WA105 Purges on Top of Cryostat

11.08.2017

- Draft [NP 02 00 00 – CEPM -00046 Cryostat and Warm Piping NP02 draft](#) is uploaded at the indico
- Proposal design of the purges at the Crossing pipes according to J.Creus Prats suggestion:
 - Signal chimneys FTS → 3.1 to 3.12 with Interface Type A*
 - All cryogenic with Interface Type A* → 10.x to 14.x

- Example for penetrations 11.2 to 11.5

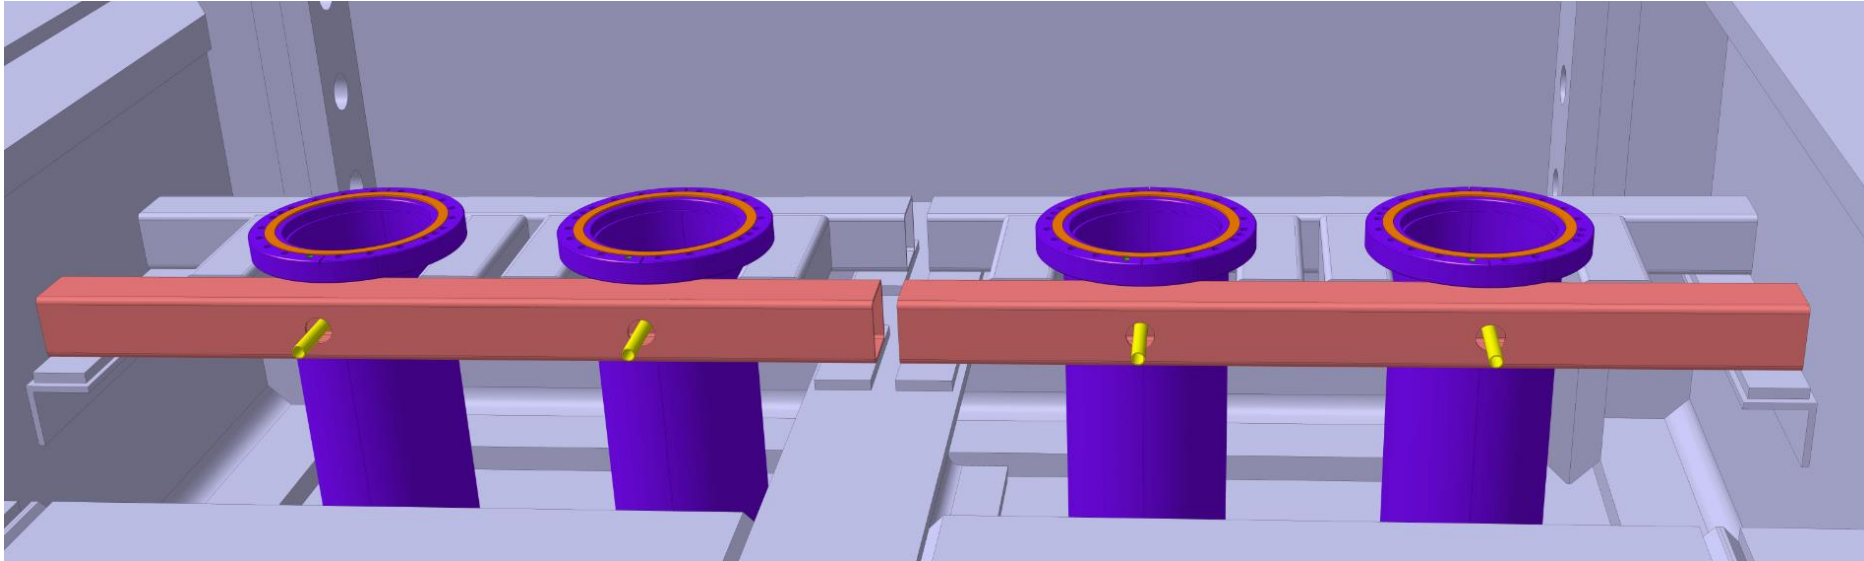
- There are some Crossing pipes that have reinforcement Square profiles 60x60mm under the flange
- Proposal is to have all the purges at 30mm from the Bottom of the Flange
- Concerning the Crossing pipes with reinforcement this would be exactly in the middle of the Square profiles
- I would propose to have a hole of 25mm diameter in the square profile for the purge.

- Purge pipe (12mm/10mm) can be welded first
- Flange will be welded from the top
- Reinforcement would be installed by sliding the purges into the 25mm holes

Cryogenic Penetration 12.3:

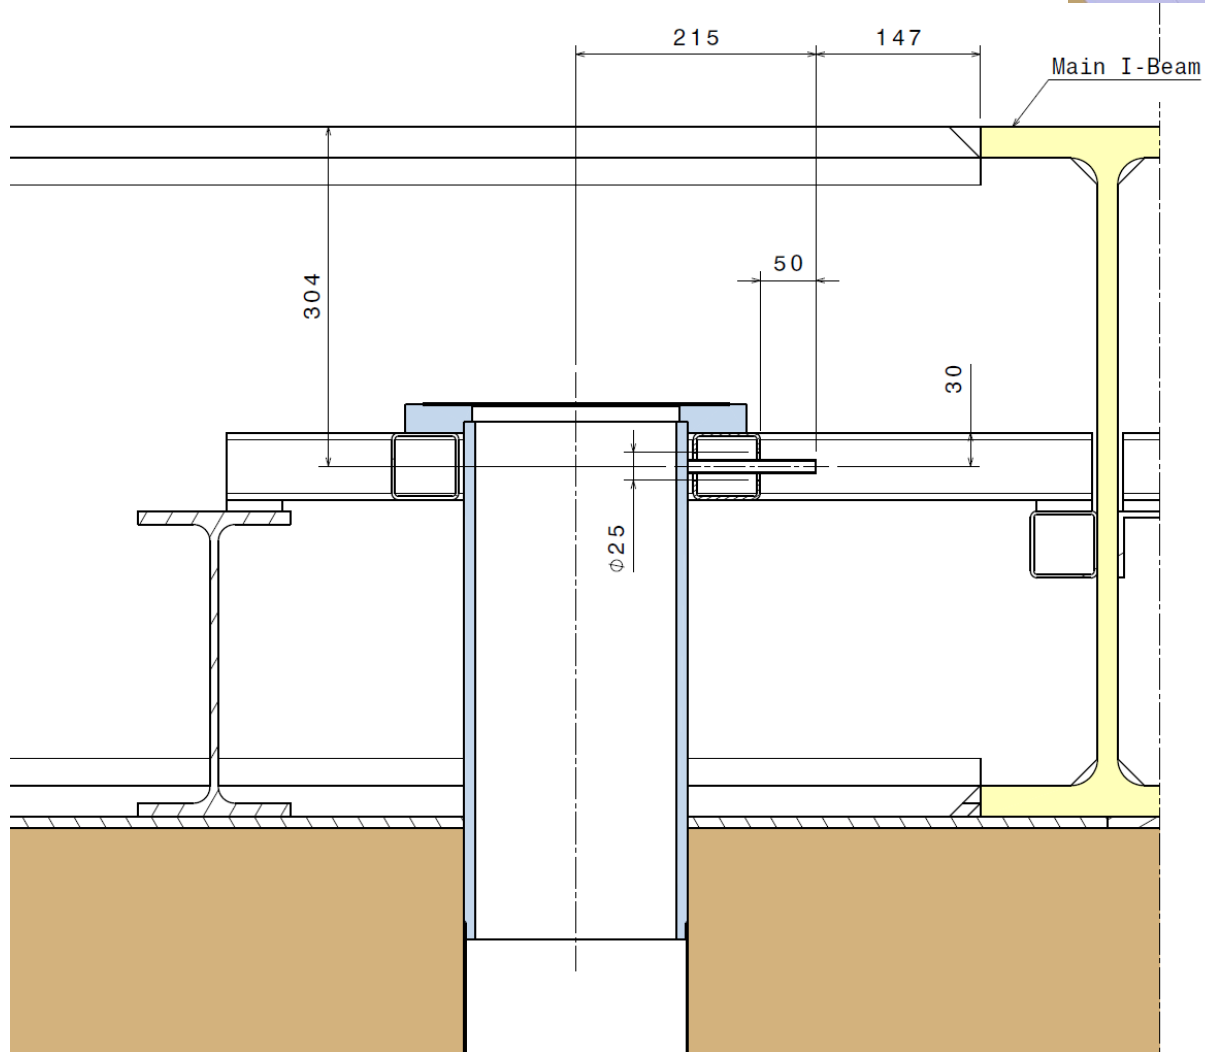
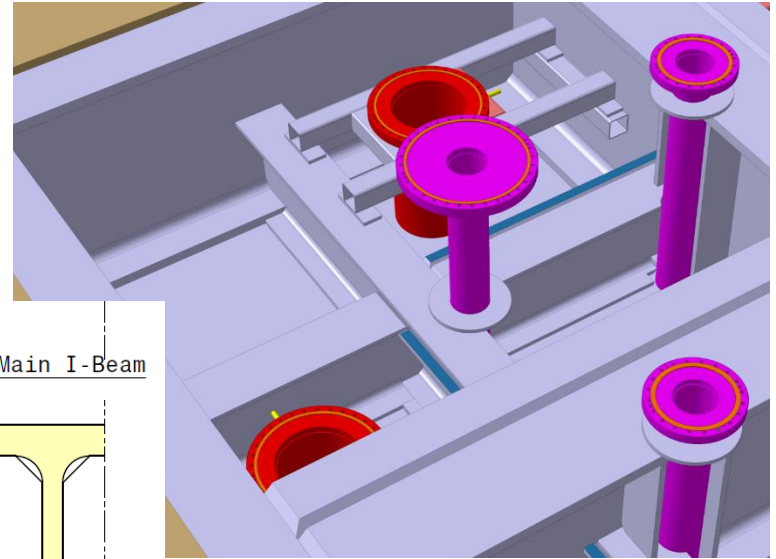
- Only remark I noticed is regarding the penetration 12.3.
- If there are no objections I would orient the purge on the opposite direction in order not to have the Main I-beam exactly in front.
- For the moment 12.3 is kept in the proposed orientation from Joaquim

- According to the drawing below the orientation of the purge can be decided
- Vertical position and length for the other purges is same as for purge at 12.3

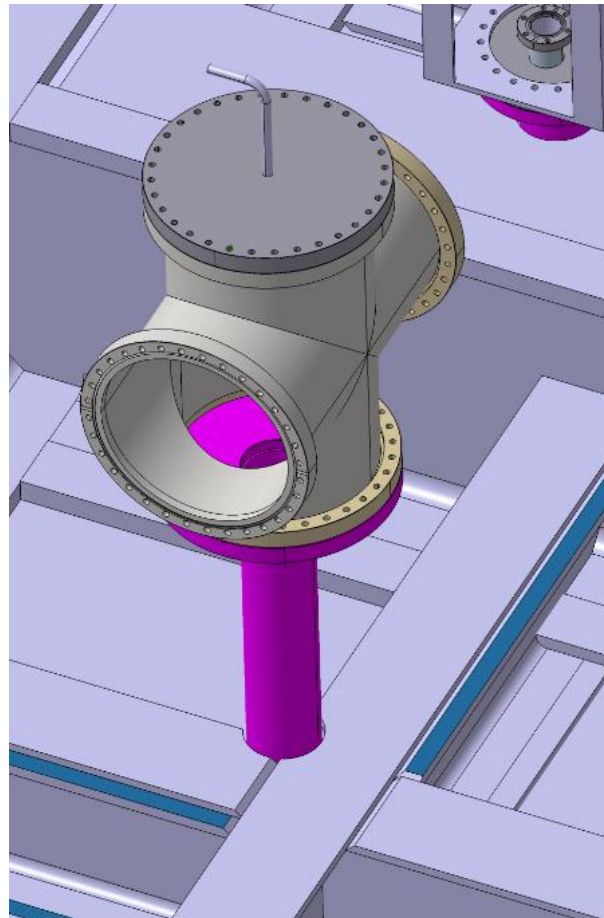
- Slow control Chimneys [2.1-4] → 2 m of bellow in order to remove the top flange and place it on the I-Beam

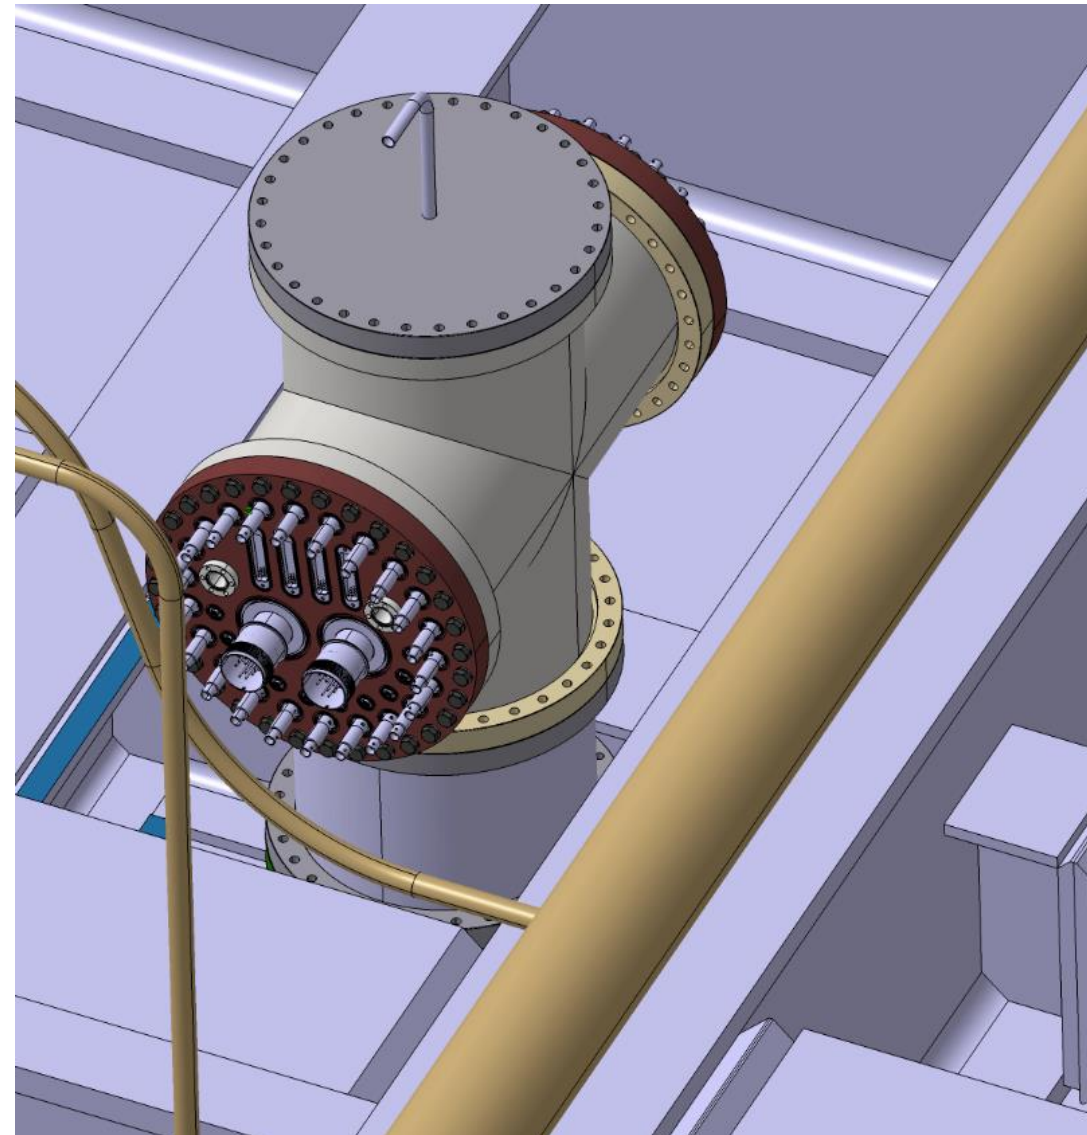
- Tank Instrumentation [9.1-2] → 2 m of bellow in order to remove the top flange and place it on the I-Beam

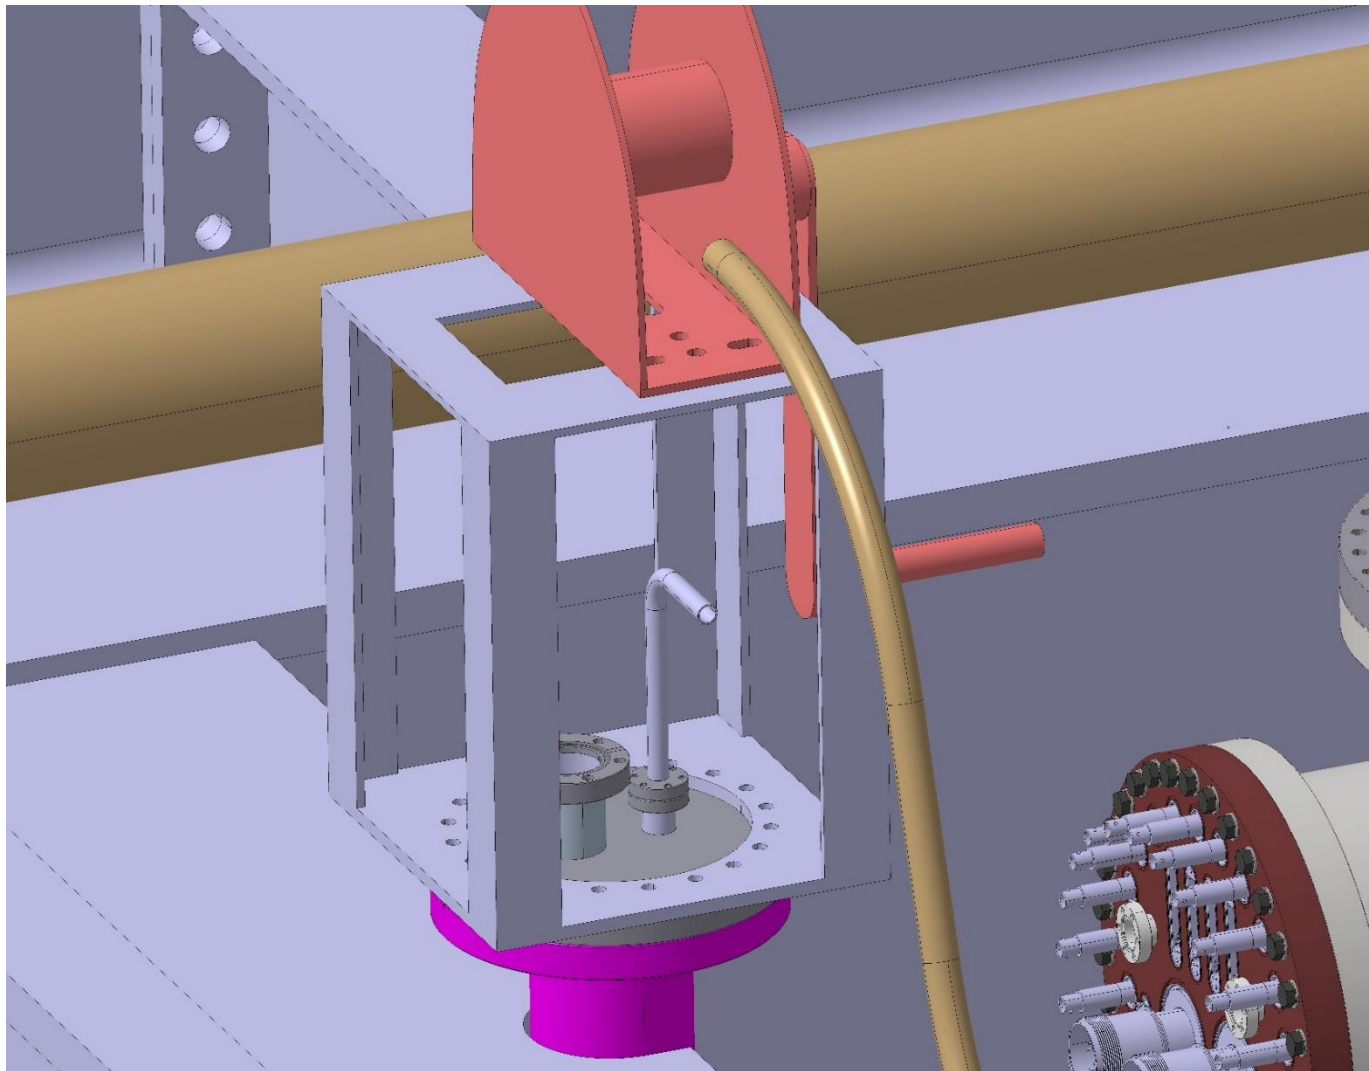
- Field Cage Suspension [1.1-16] → 1m of bellow in order to have the CF16 free for Field Cage installation
